**The Philadelphia Parking Authority
701 Market Street, Suite 5400
Philadelphia, PA 19106**

Bid No. 24-17

**Electrical Upgrades at Autopark at Fashion District and Autopark at Olde City
Addendum Three**

Bid No. 24-17 Addendum #3 - Appendix A

Revised Sheet E-600

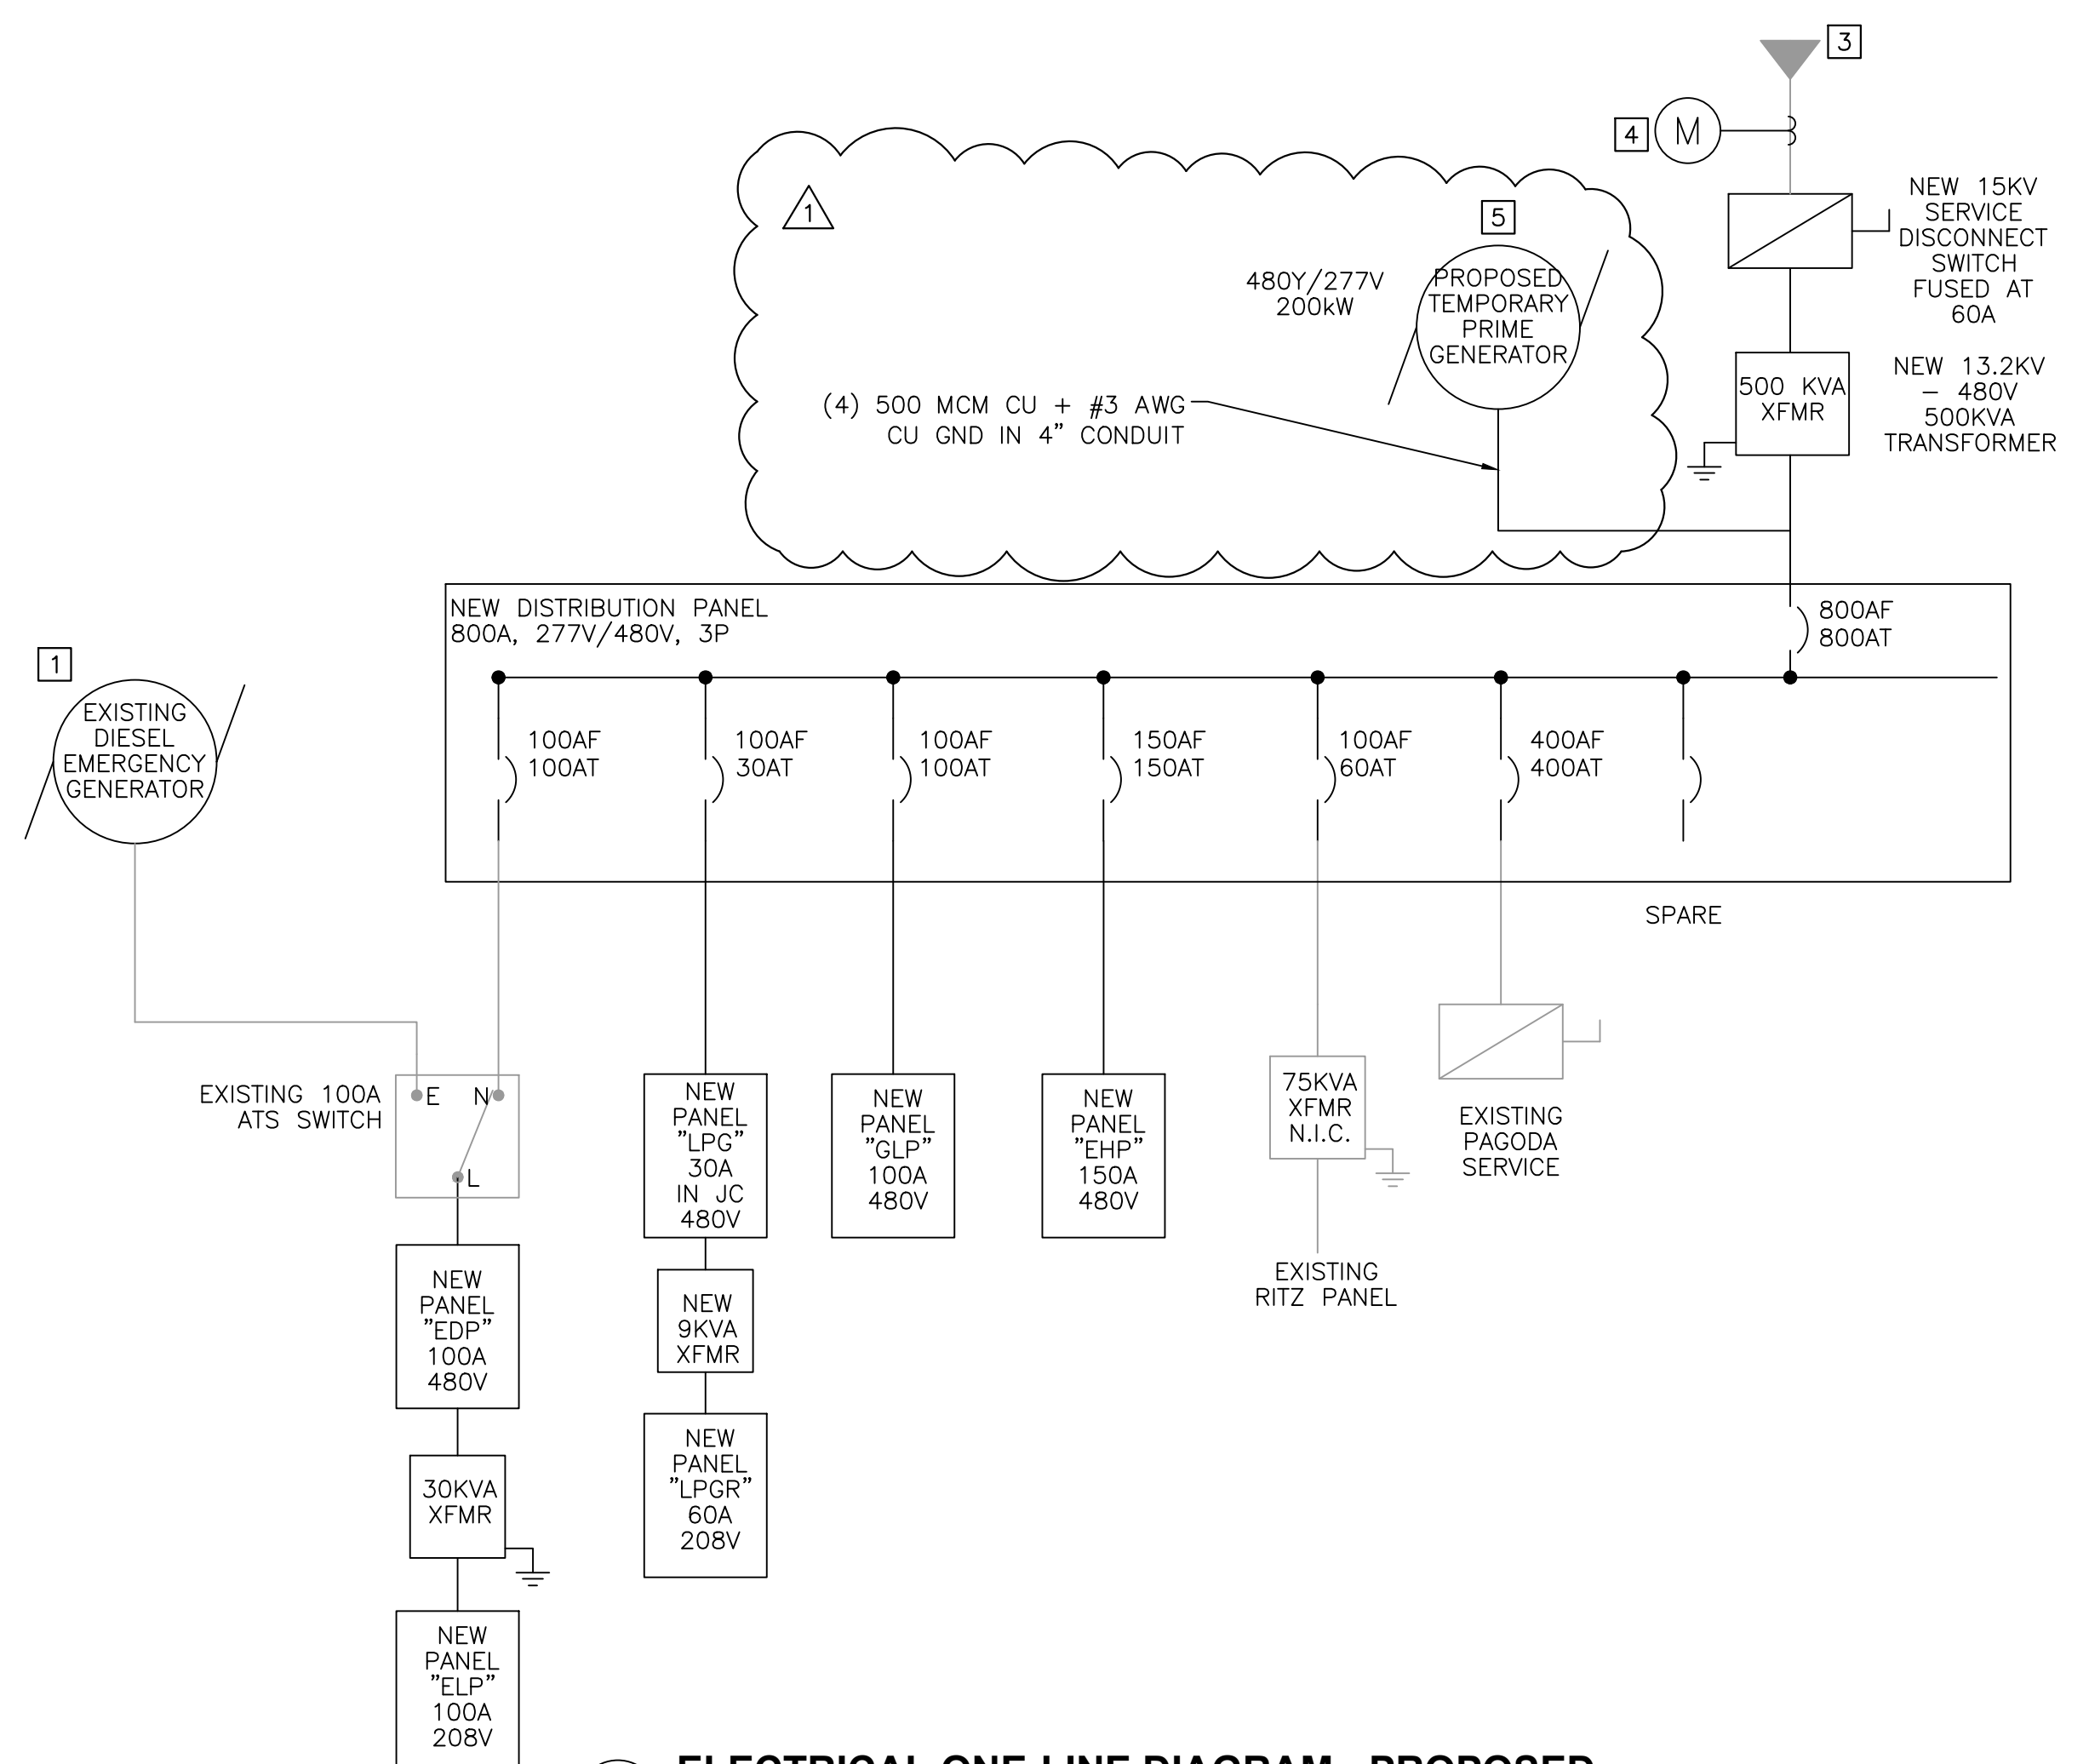
- 1. Bid Due Date: The bid due date has been extended to Wednesday, August 14, 2024.**
- 2. Sheet E-600: Sheet E-600 has been revised to show temporary power on the one-line diagram. Refer to Appendix A of this addendum.**

- SHEET NOTES:**
- 1 GENERATOR REPLACED IN 2023 THROUGH A SEPERATE PROJECT
 - 2 COORDINATE SERVICE SHUTDOWN WITH PECO
 - 3 COORDINATE SERVICE ENERGIZATION WITH PECO
 - 4 OBTAIN METER FROM PECO
 - 5 TEMPORARY GENERATOR TO BE PRIME POWER DURING DEMOLITION OF EXISTING SERVICE AND INSTALLATION OF PROPOSED SERVICE EQUIPMENT. CONTRACTOR SHALL COORDINATE WITH PPA 2 WEEKS IN ADVANCE OF UTILITY POWER DISCONNECT AND UTILITY POWER RECONNECT.
